EPRI Independent Peer Review of the TEPCO Seismic Walkdown and Evaluation of the Kashiwazaki-Kariwa Nuclear Power Plants

A Study in Response to the July 16, 2007, NCO Earthquake

Independent Peer Review, January 2008

Picture Numbers: CIMG3881 (2-1a) CIMG3886 (2-1b)

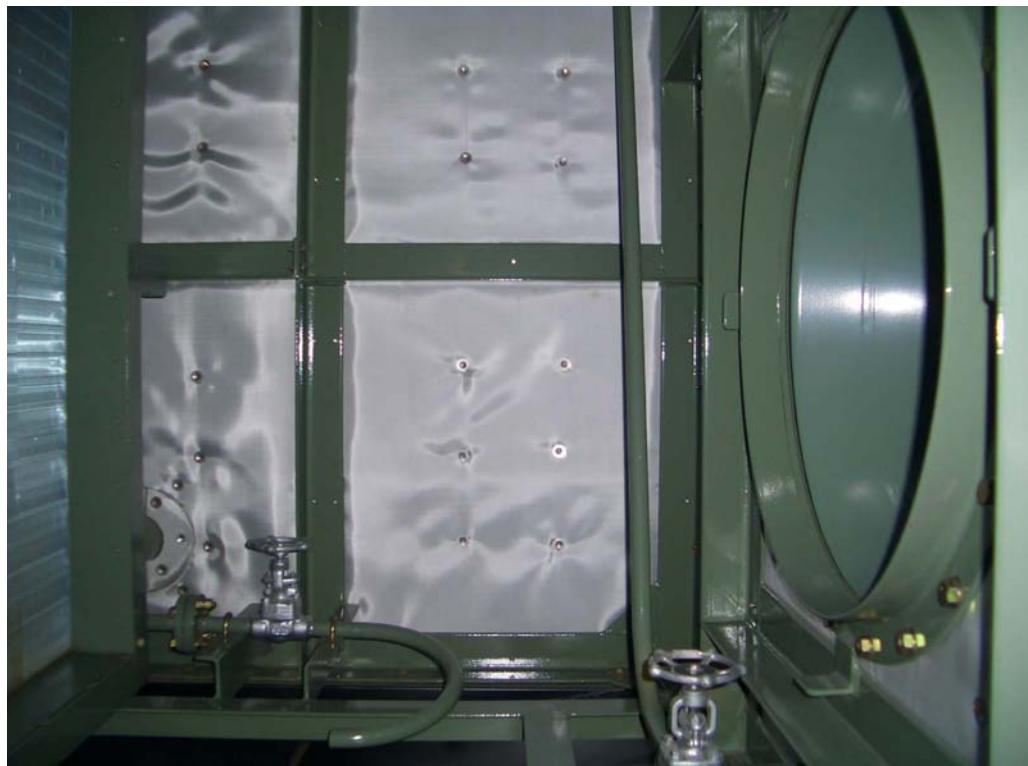
1. Check equipment anchorage/isolation mounts for damage; e.g., stretching or loosening of anchor bolts or nuts; rocking or sliding of equipment. ☒
Comments: Anchor bolts show no distress – no isolators
2. Check for damage to attached conduits and ground straps. ☒
Comments: Only conduit with plenty of slack
3. Check for damage to air handler due to seismic loads imposed by attached ducts or tearing of fabric noise eliminators. ☒
Comments: No visible damage
4. Check for damage due to impact or earthquake induced flooding or spraying ☒
Comments: Very little interaction potential, rugged components in area
5. Check for belt tightness and/or slippage; e.g., belt smoke/odor ☐
Comments: Direct drive – not sure if this has been operated
6. Check local alarms, breakers and protective devices for actuation/trips. ☐
Comments: N/A
